PLANNING COMMISSION STAFF REPORT CRESTVIEW CROSSING PLANNED UNIT DEVELOPMENT AND CONDITIONAL USE PERMIT

HEARING DATE: August 09, 2018

FILE NO: PUD18-0001/CUP18-0004

REQUEST: The application proposes a mixture of commercial use, single-family homes, cottage style homes, affordable housing and multi-family homes. The proposed development on 33.13 acres of land includes 18 single-family homes, 230 cottage homes and 51 multi-family homes with modifications to the base zone's dimensional requirements as permitted through the PUD process. The conditional use permit request is for allowing residential use on C-2 Community Commercial zoned property.

SHEET NUMBER
C300

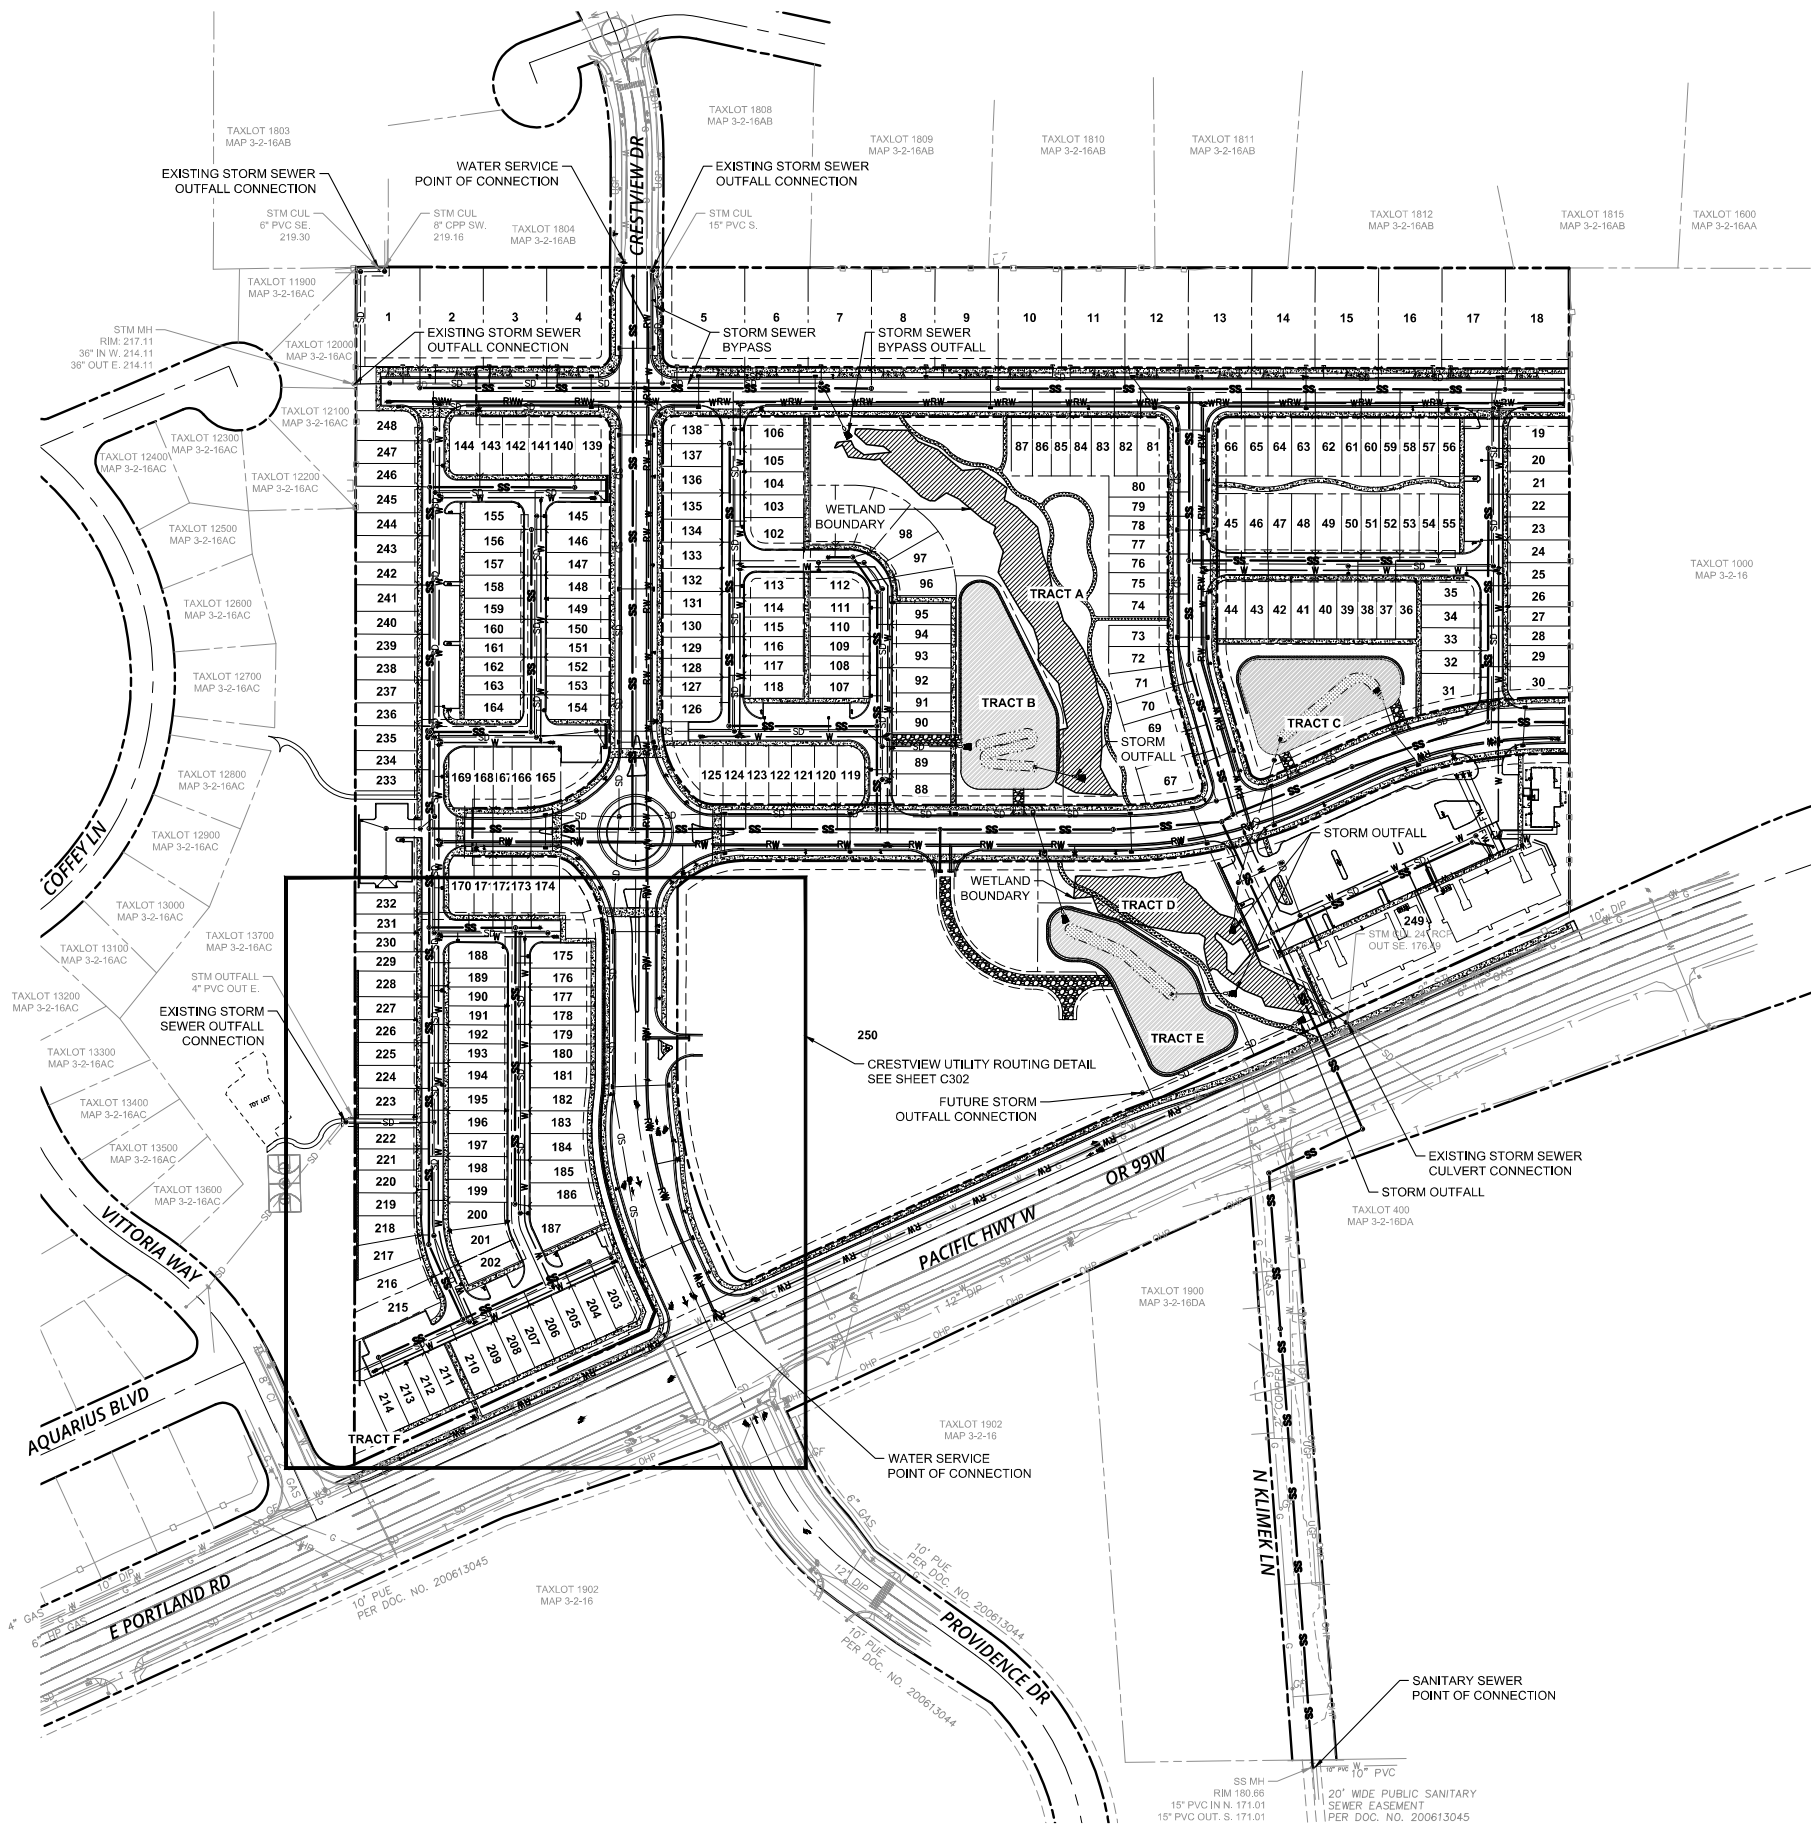
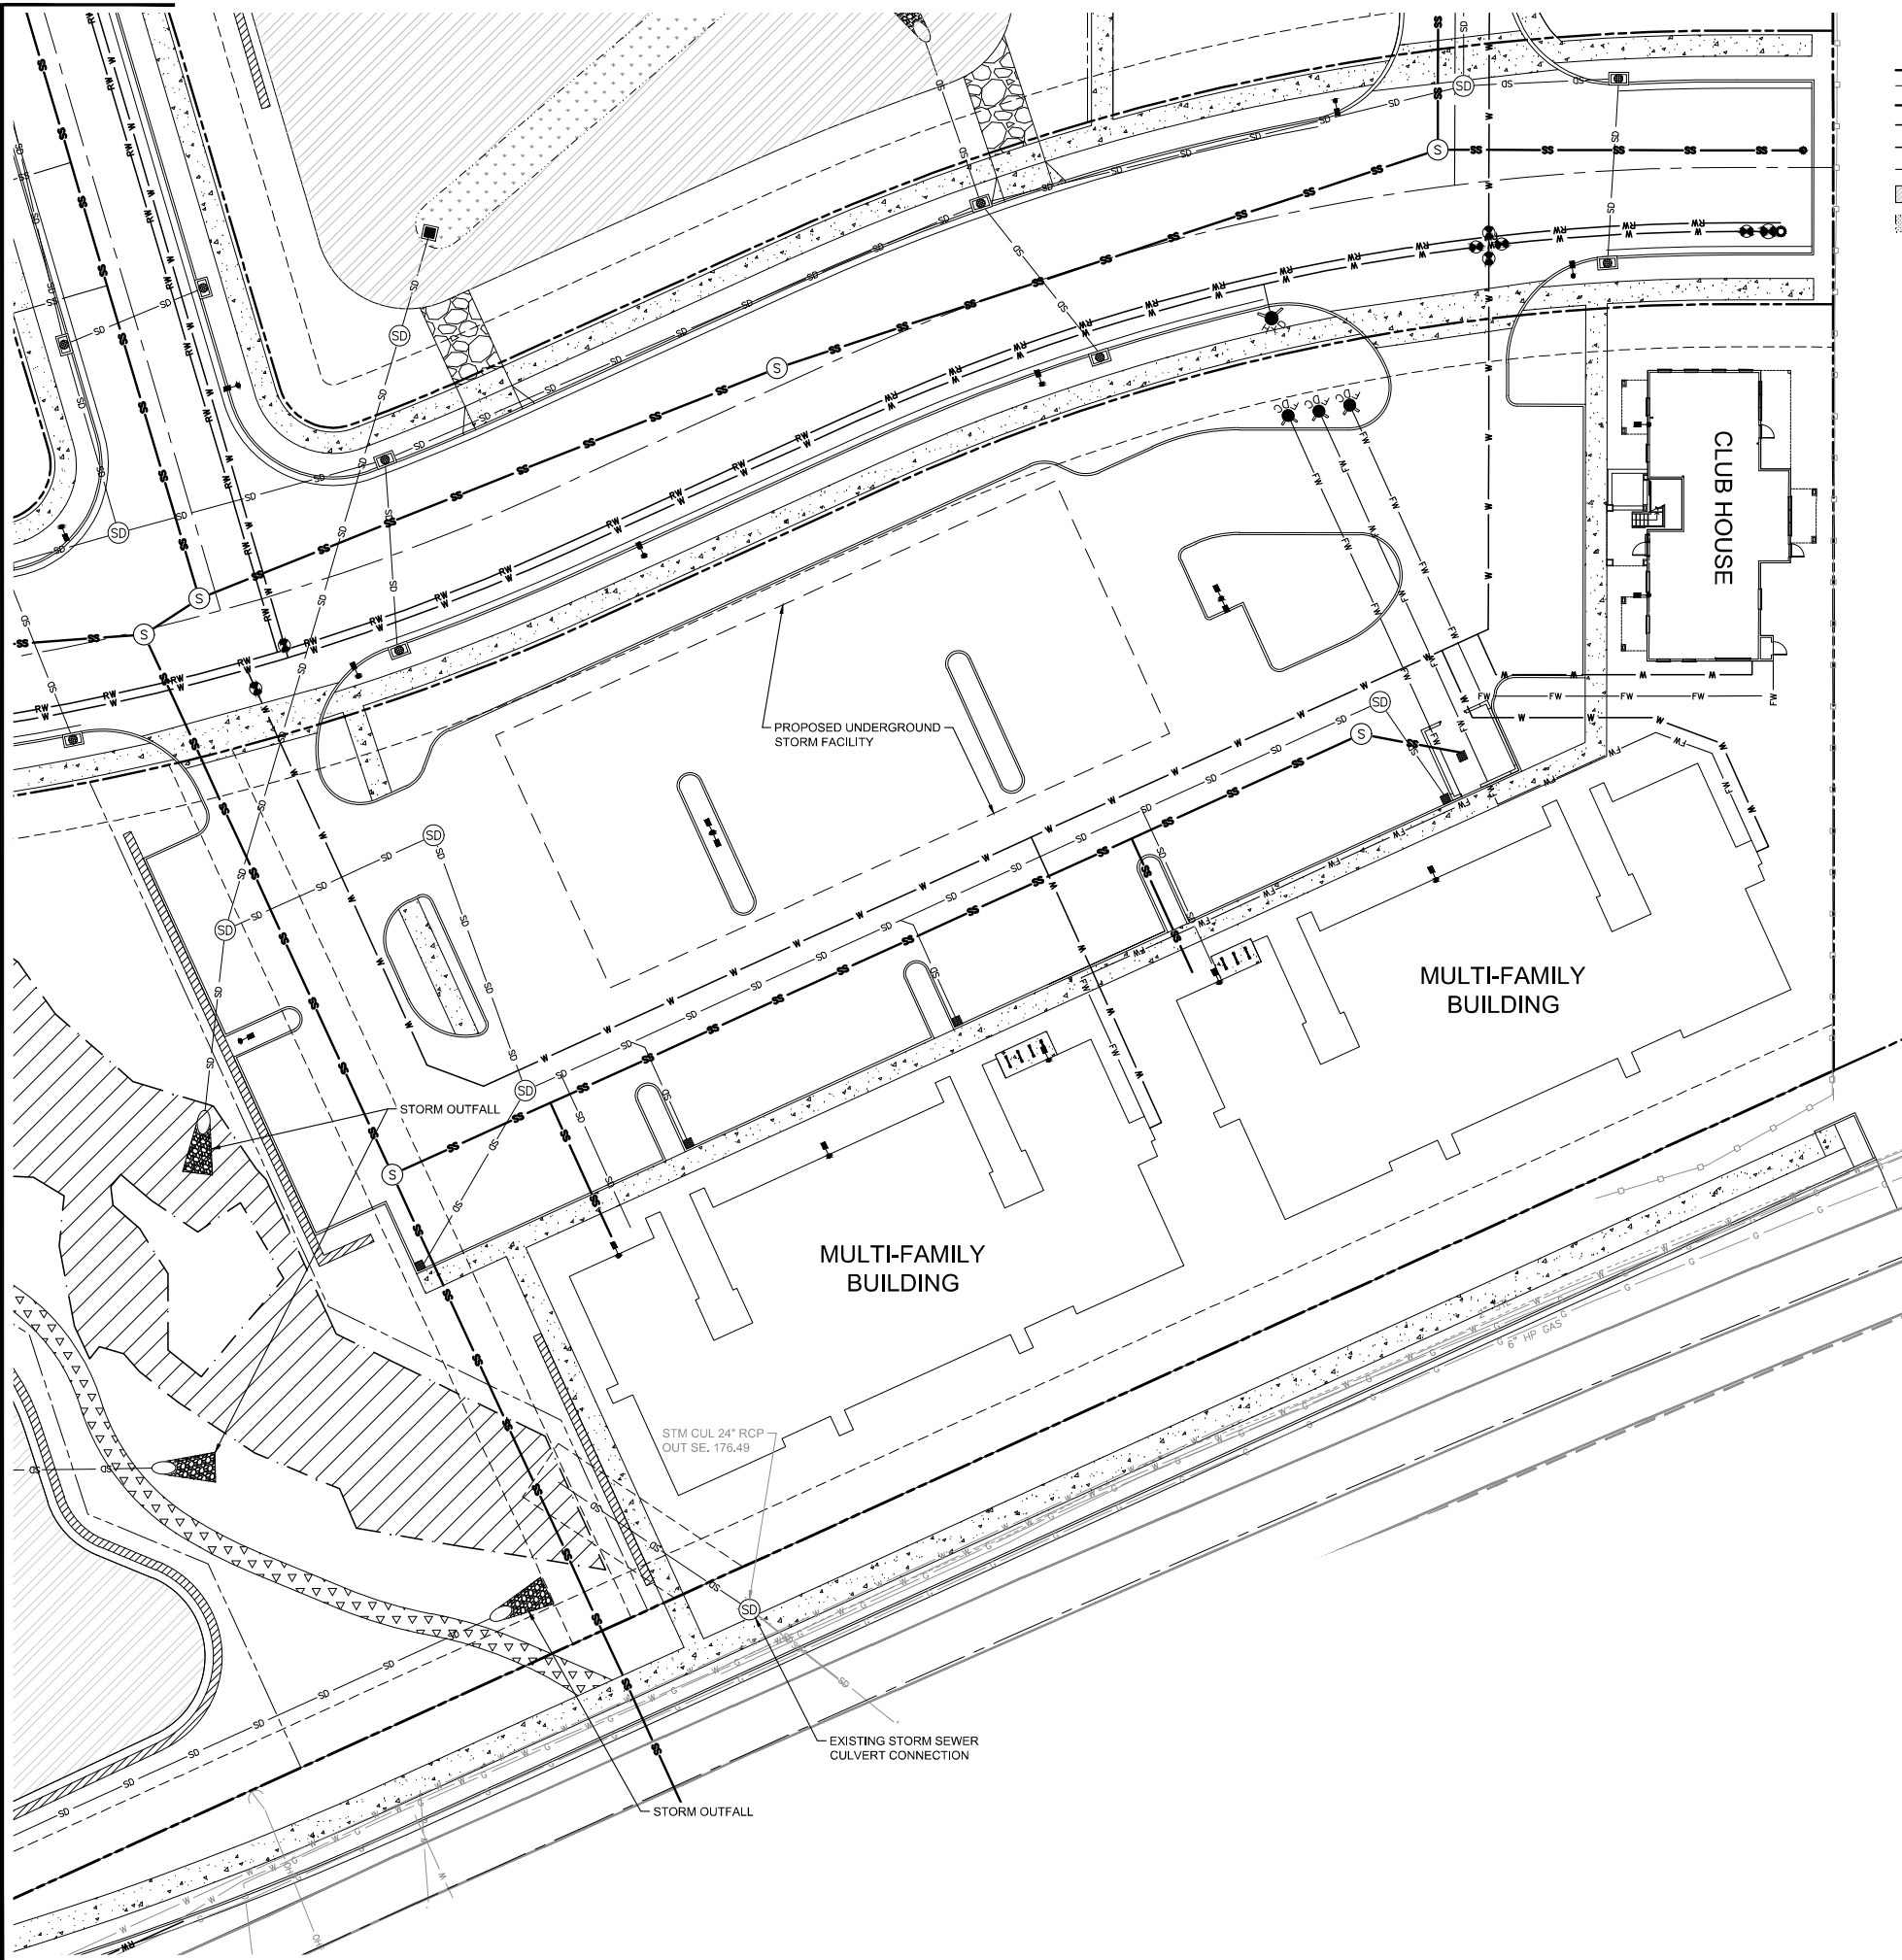
* Per private road cross-section shown on sheet C300.

Because the applicant has been unclear on the intended width of walkways along private streets, the applicant shall follow the city engineer requirement for sidewalks along private streets to be 5-foot wide matching the applicant’s cross-section detail on sheet C300.

1. The applicant shall provide documentation for maintenance and financing of maintenance for the private streets.
2. The applicant shall follow the city engineer requirement for sidewalks along private streets to be 5-foot wide matching the applicant’s cross-section detail on sheet C300.

P:\17393-JTS-CRESTVIEW CROSSING\CADD\C200 TYPICAL SECTIONS.DWG

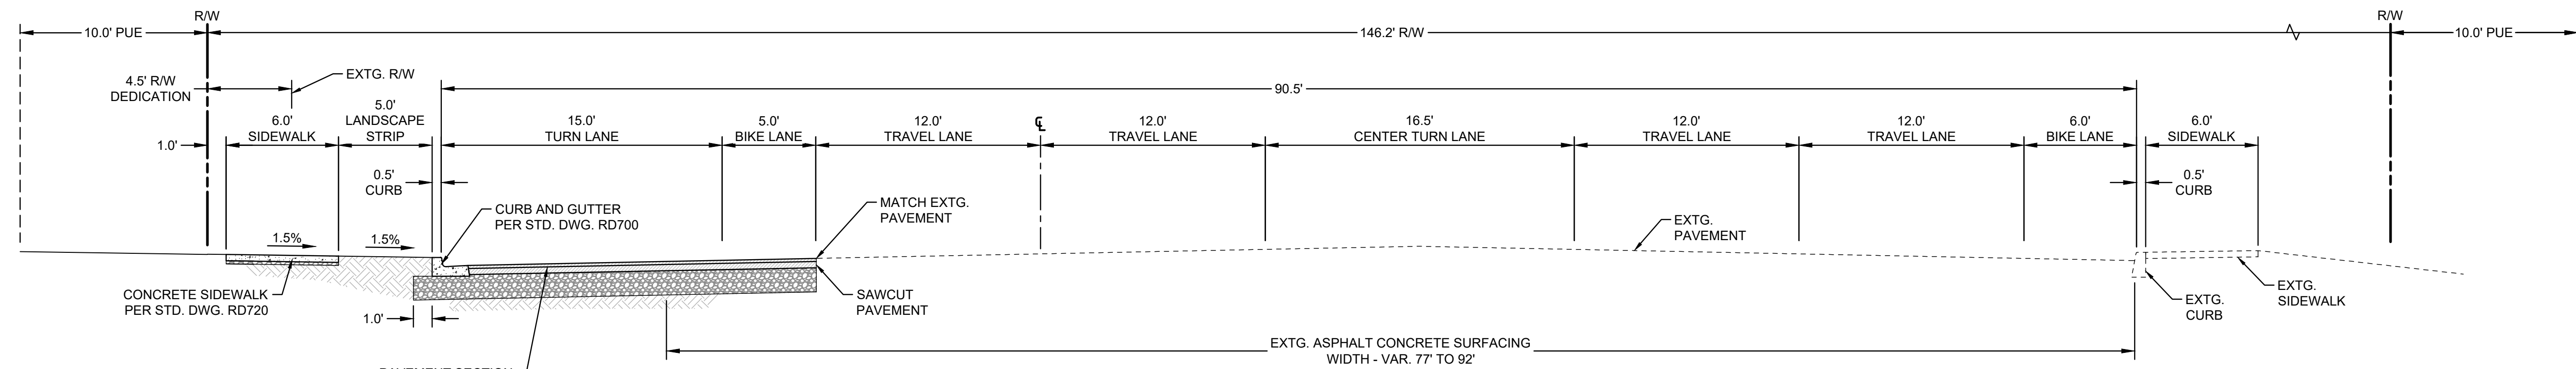
Finding: The applicant is proposing to extend E Crestview Drive, a major collector, from its northern terminus to E Portland Road. The applicant has proposed a cross-section on sheet C200 that varies and does not match the City's cross-section for a major collector roadway which requires a minimum of 60-feet of right of way:

The applicant is showing Public Street B designated as a minor collector running east-west through the PUD. The applicant has proposed a cross-section on sheet C200 that does not clearly articulate the dedication of roadway space. The following cross-section meets the City's standard for a minor collector and requires 64-feet of right of way:

The applicant is showing Public Street C and Public Street D designated as local residential streets. The applicant has proposed a cross-section on sheet C200 that does not match the City's Transportation System Plan based on a local road functional classification. The following cross-section meets the City's standard for a local residential street and requires 56-feet of right of way:
